City of Surrey
PLANNING & DEVELOPMENT REPORT

File: 7917-0047-00

Planning Report Date: November 4, 2019

RESPONSE TO DP RESUBMISSION FOR COUNCIL - FILE NUMBER #17-0047

Site Plan

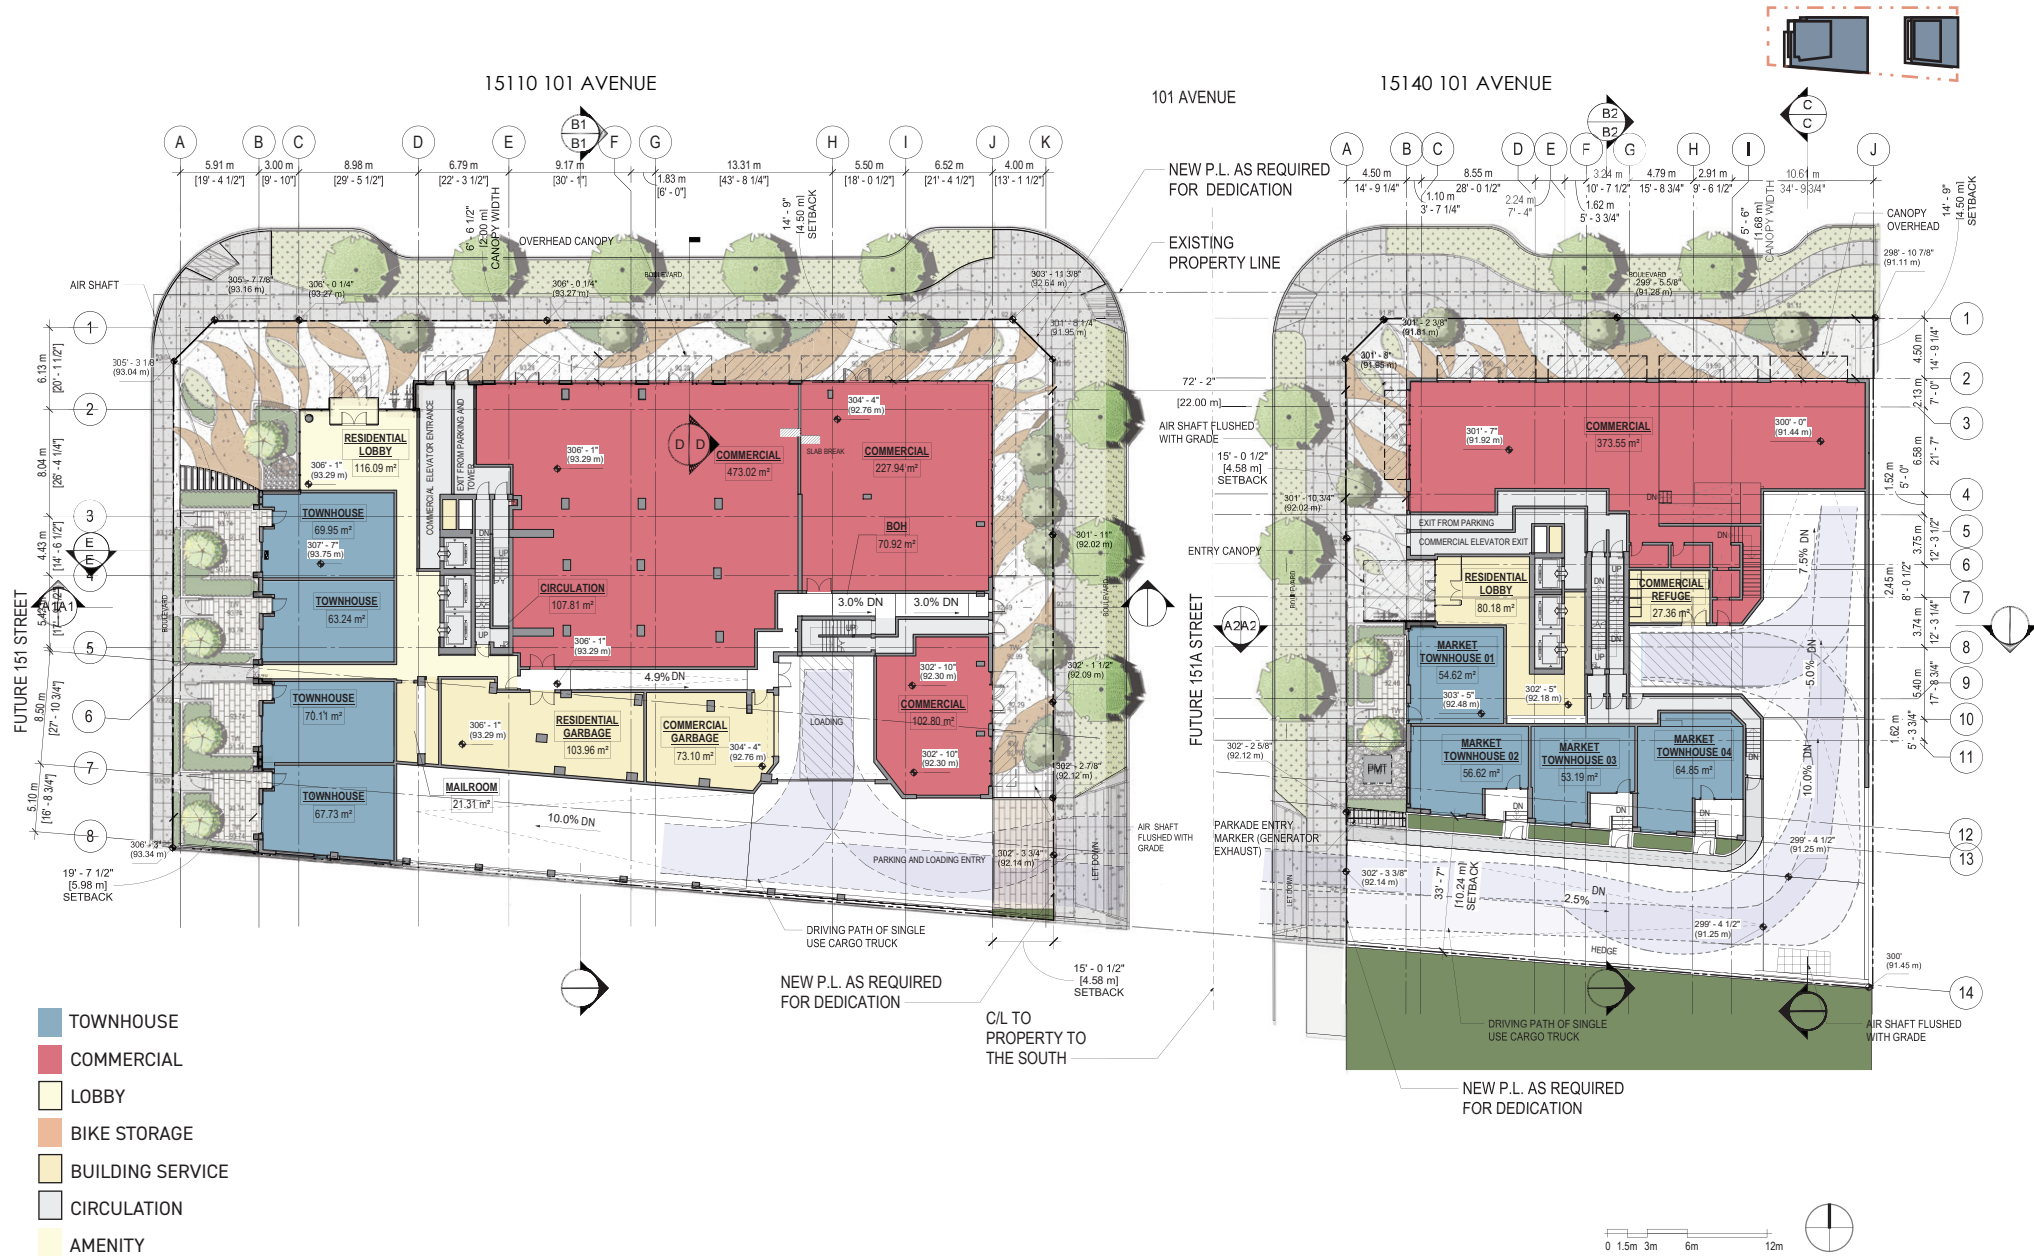
- Consider options to mediate the grade change between the public sidewalk and commercial terrace as the planters create separation between commercial storefront and public realm.

- Suggest an alternate way to mediate the grade change along the townhomes without the use of planters.

(Hedge has been removed from the south side of the mid-rise entry ramp and put against the patio spaces of the townhouses. The entry ramp has been reconfigured to allow for at grade entry to the neighbouring site to the east. Noted on both Architectural Site Plan and Landscape drawings.)

(The exterior approach to the tower at the northwest corner of the site has been revised to provide a much more open and welcoming entry for the lobby. Noted on both Architectural Site Plan and Landscape drawings.)

(The grade has been revised to eliminate any stairs that run perpendicular to the sidewalk. Noted on both Architectural Site Plan and Landscape drawings.)

(Due to the City's desired effect of creating a separation between the townhouse patios and the street by using an elevation change and screen, this item could not be incorporated without the use of a planter. The planters for the trees on 101 have been removed.)
